ANADROMOUS WATERS CATALOG/ATLAS
CORRECTION FORM

Describe Change(s): Changes involve corrections to annotation where fish species codes are missing or AWC# is in error

Nomination Number: CB-368

From: Barnhill, Carol A (DFG)
Sent: Friday, February 13, 2009 6:19 PM
To: Johnson, J D (DFG)
Subject: AWC species errors

333-10-11200
RIVER
333-10-11200-2022
COs
COs,DVr,COs
CHp,COp,Kp,Ps,Ss,DVp,Wp
Creek
Road
Creek
Perkinsville
COs
333-10-11200-2022-3019
Banner Peak
Banner Creek
Hill
DVr
DVr
DVr
Cooper Gulch
Creek
Gulch
Hill
ROAD
15
14
13
12
11
35
33

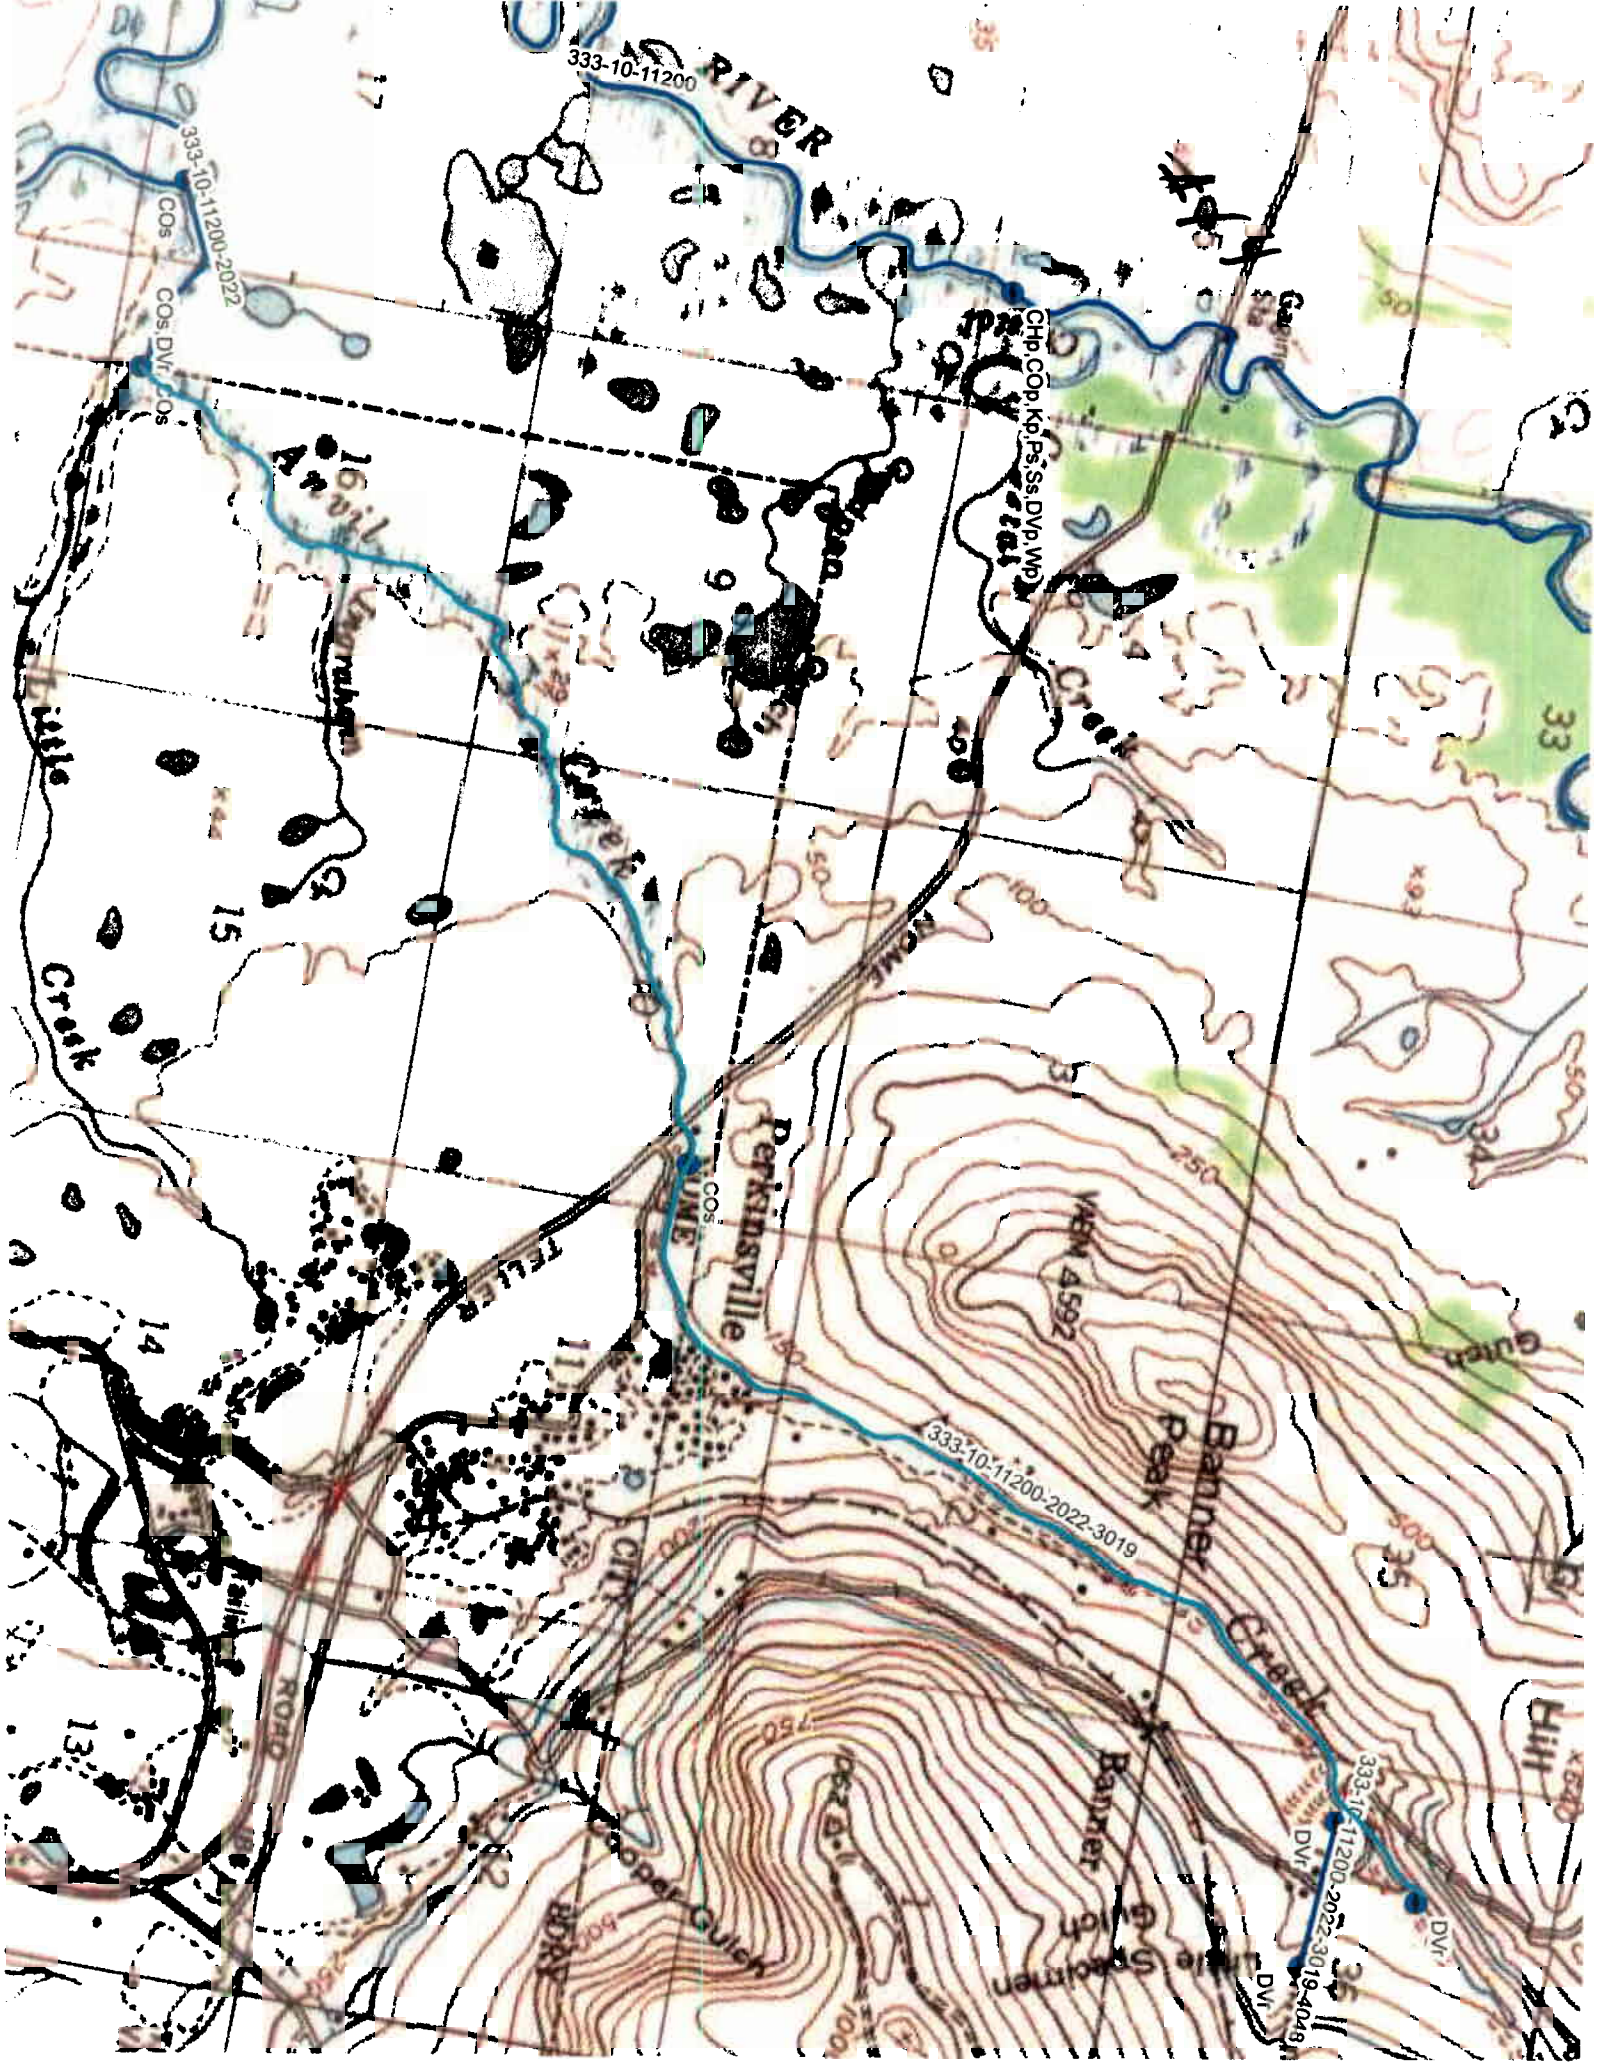
13	331-00-10490-2205-3017	Ambler River A-4	No W in -2205
14	333-10-11200-2022-3019	Nome C-1 & C-2	No DV in -2022

AWC#	Atlas map	Error on map	Corrective action
331-00-10490-2205	Ambler River A-4	No W in -2205	Add Whitefish to water body
333-10-11200-2022	Nome C-1	No DV in -2022	Add Dolly Varden to water body
333-10-11200-2022	Nome C-2	No DV in -2022	Add Dolly Varden to water body
334-30-11000-2701-3339-4007	Unalakleet B-4	No CH,W in -4007	Add Chum salmon & whitefish to water body

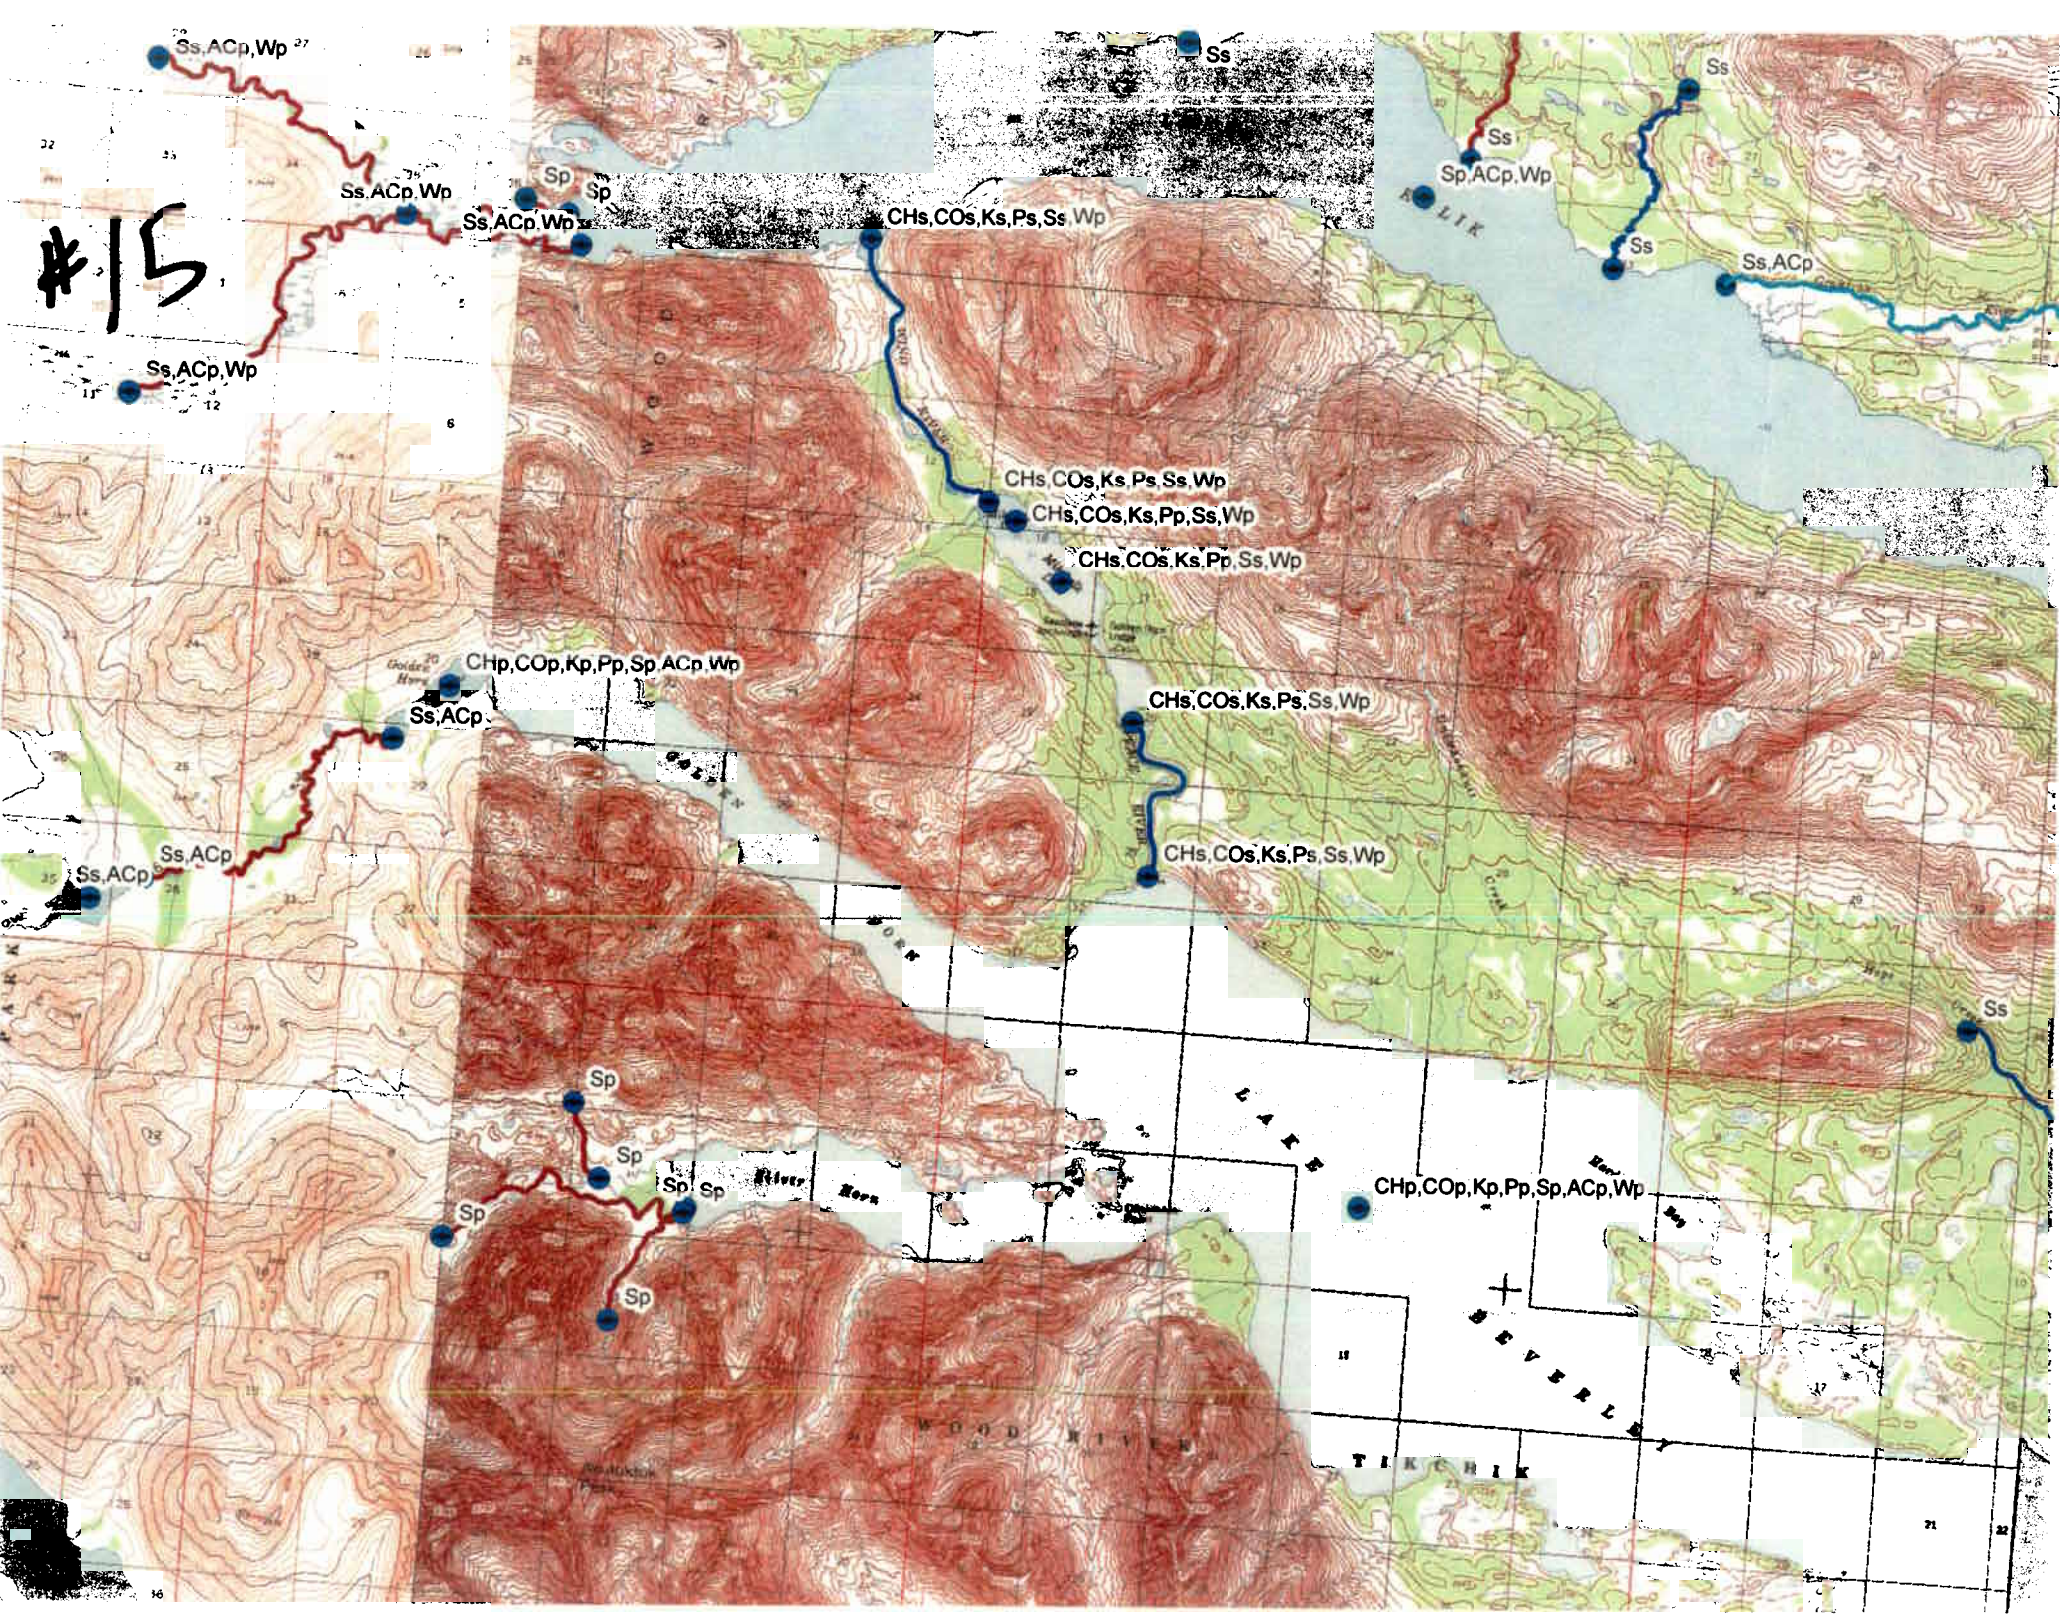
15	325-30-10100-2031-3118-4212-5074-6011-7043	Dillingham D-8 & C-8	No AC in -6011 or -0010 or -5074

AWC#	Atlas map	Error on map	Corrective action
325-30-10100-2031-3118-4212-5074	Dillingham C-8	No AC in -5074	Add Arctic Char to water body
325-30-10100-2031-3118-4212-5074-6011	Dillingham C-8	No AC in -6011	Add Arctic Char to water body
325-30-10100-2031-3118-4212-5074	Dillingham D-8	No AC in -5074	Add Arctic Char to water body
325-30-10100-2031-3118-4212-5074-6011	Dillingham D-8	No AC in -6011	Add Arctic Char to water body

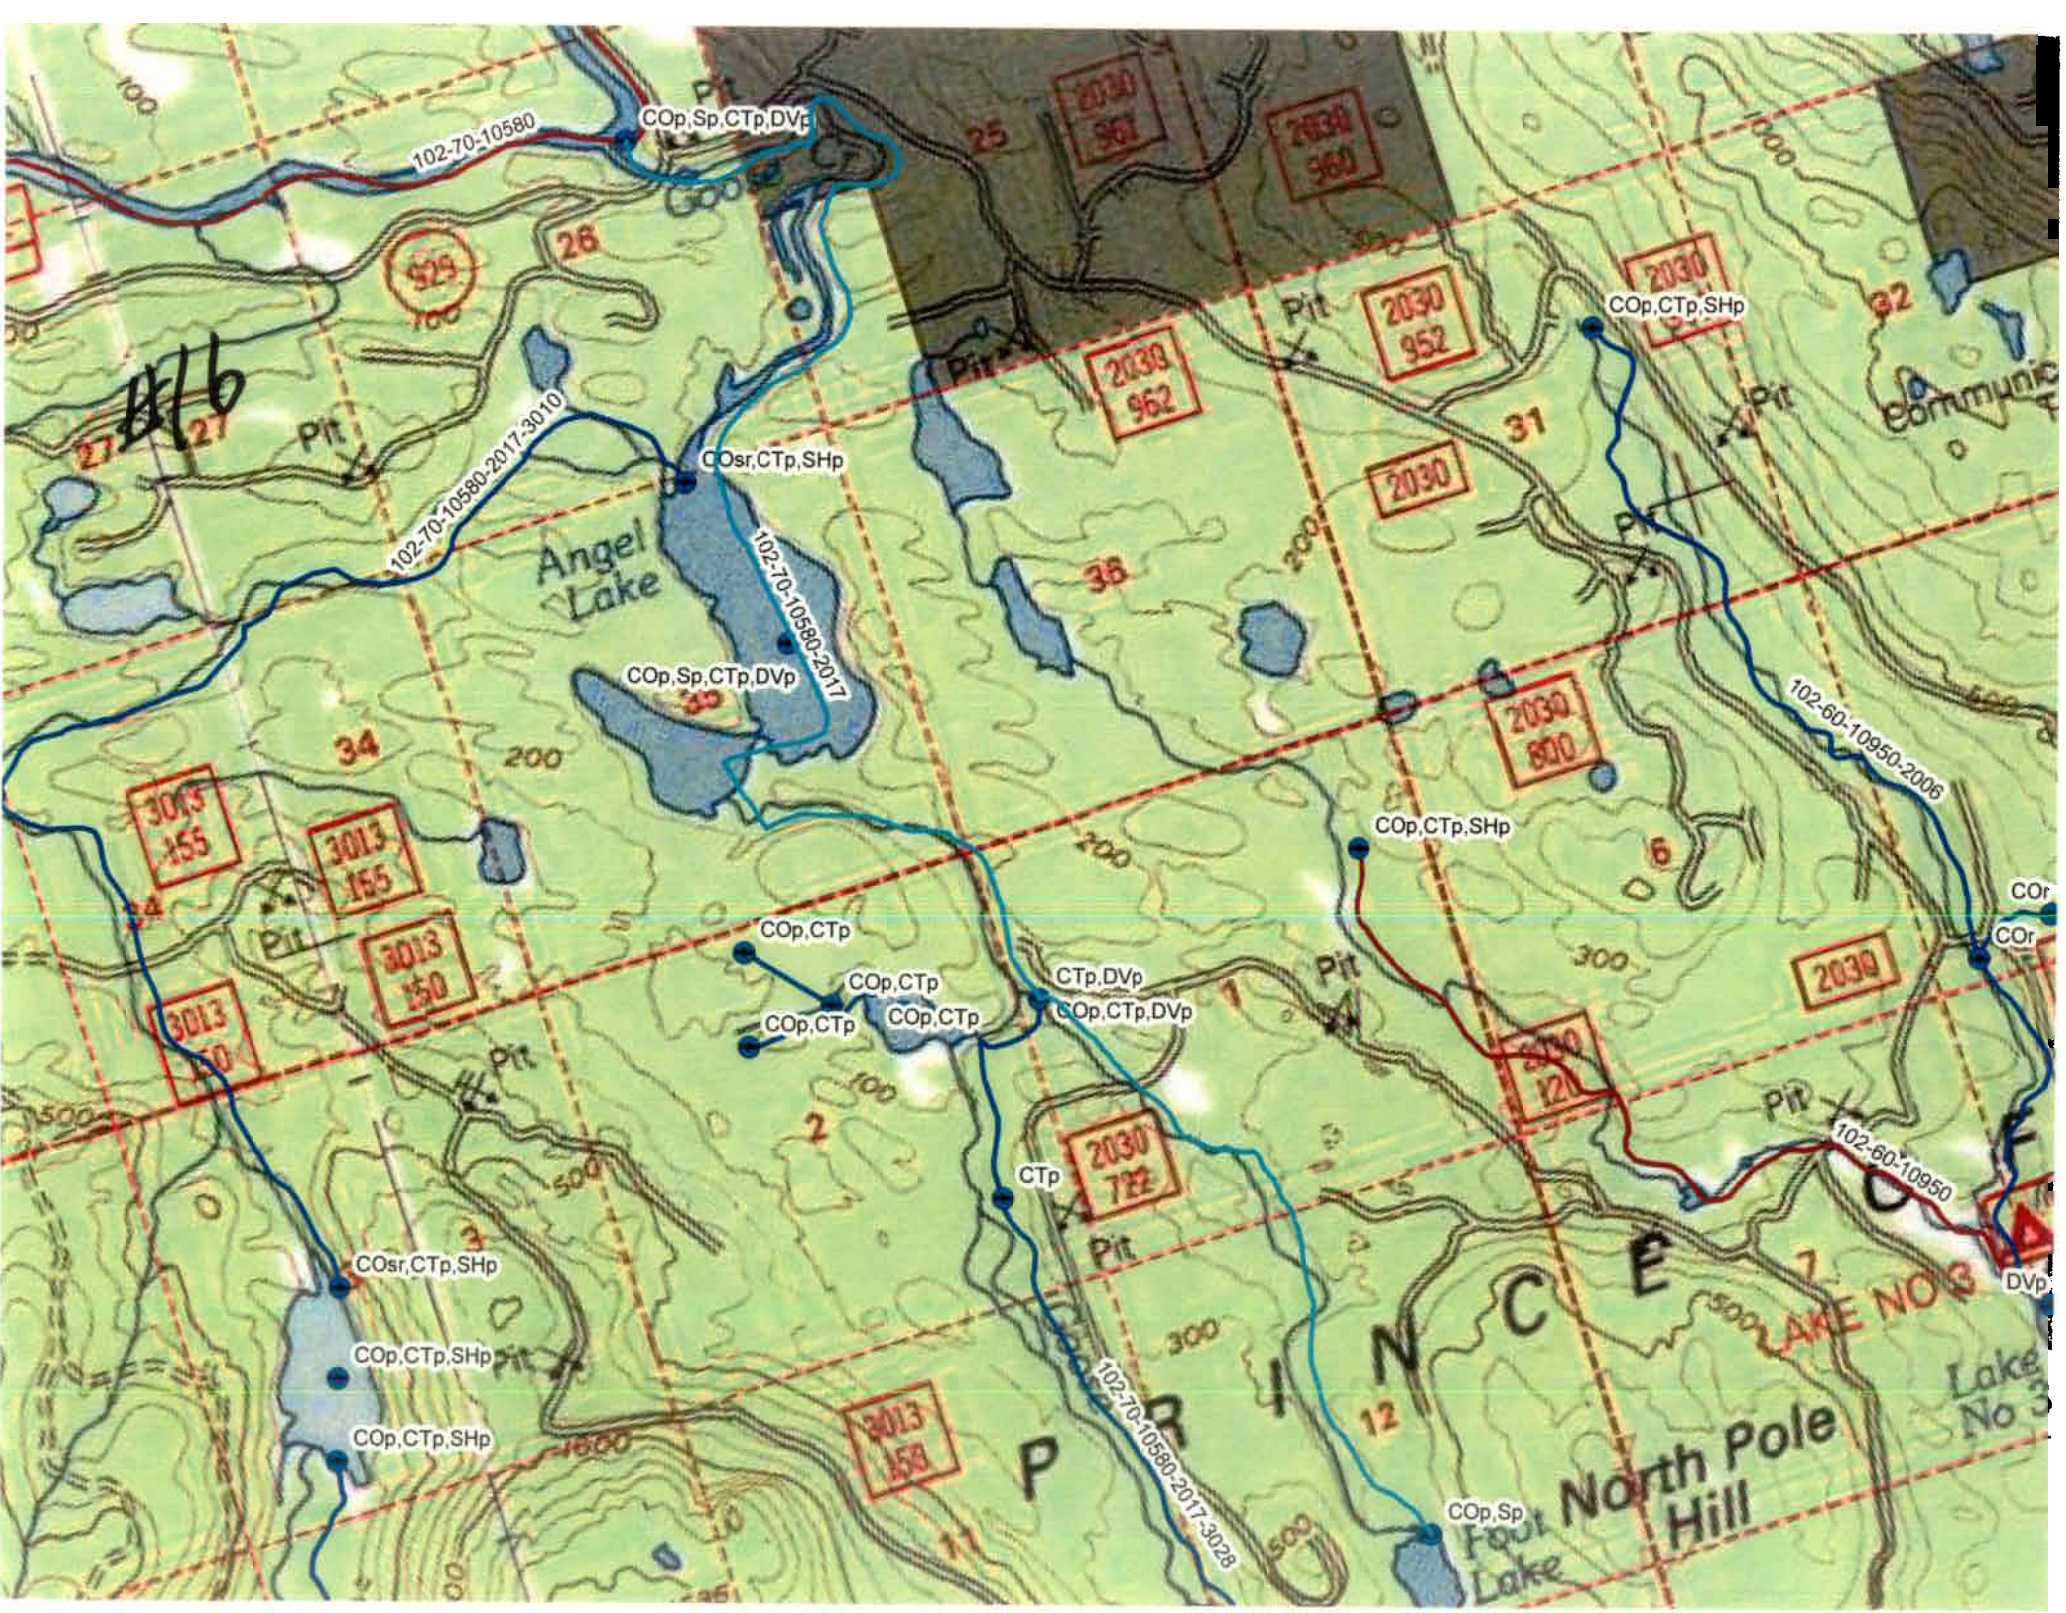
16	102-70-10580-2017-3010	Craig C-2	No SH in -2017 or -0010
17	106-30-10670-2004-3028-4006	Craig D-3	No P in -3028
18	111-50-10750-2033-3007	Juneau B-2 SW	No CT,DV in -2033
	111-50-10750-2033-3014	Juneau B-2 SW	No CT,DV in -2033
	111-50-10750-2033-3018	Juneau B-2 SW	No CT,DV in -2033
19	113-81-10110-2012-3002	Sitka C-6 & C-7	~~No CH,P in -2012~~ (should this be a 3rd order?)
20	115-32-10250-2008-3004	Skagway B-2	No K in -2008
21	115-32-10250-2077-3136-4002	Skagway B-4 NE	No CT in -3136
22	182-70-10100-2020-3021	Yakutat C-4 SW & C5SE	No SH,DV in -2020
	~~182-70-10100-2022-3011~~	~~Yakutat C-4 SW~~	~~No SH in -2022~~
23	182-70-10100-2022-3017	Yakutat C-4 SW	No SH in -2022

AWC#	Atlas map	Error on map	Corrective action
192-30-10100-2040	Bering Glacier A-5	No K in -2040	Add Chinook salmon to water body
192-41-10100-2022-3007	Bering Glacier A-5	No CO in -3007	Add coho salmon to water body
102-70-10580-2017	Craig C-2	No SH in -2017	Add Steelhead Trout to water body
106-30-10670-2004-3028	Craig D-3	No P in -3028	Add pink salmon to water body
111-50-10750-2033	Juneau B-2	No CT,DV in -2033	Add Cutthroat Trout & Dolly Varden to water body
111-50-10750-2033	Juneau B-2 SW	No CT,DV in -2033	Add Cutthroat Trout & Dolly Varden to water body
113-81-10110-2010	Sitka C-6	Renumbered to allow additional AWC#	Renumber as 113-81-10110-2008
113-81-10110-2012-3002	Sitka C-6	Should be 2nd level water body	Renumber as 113-81-10110-2010
115-32-10250-2008	Skagway B-2	No K in -2008	Add Chinook salmon to water body
115-32-10250-2077-3136	Skagway B-4	No CT in -3136	Add Cutthroat Trout to water body
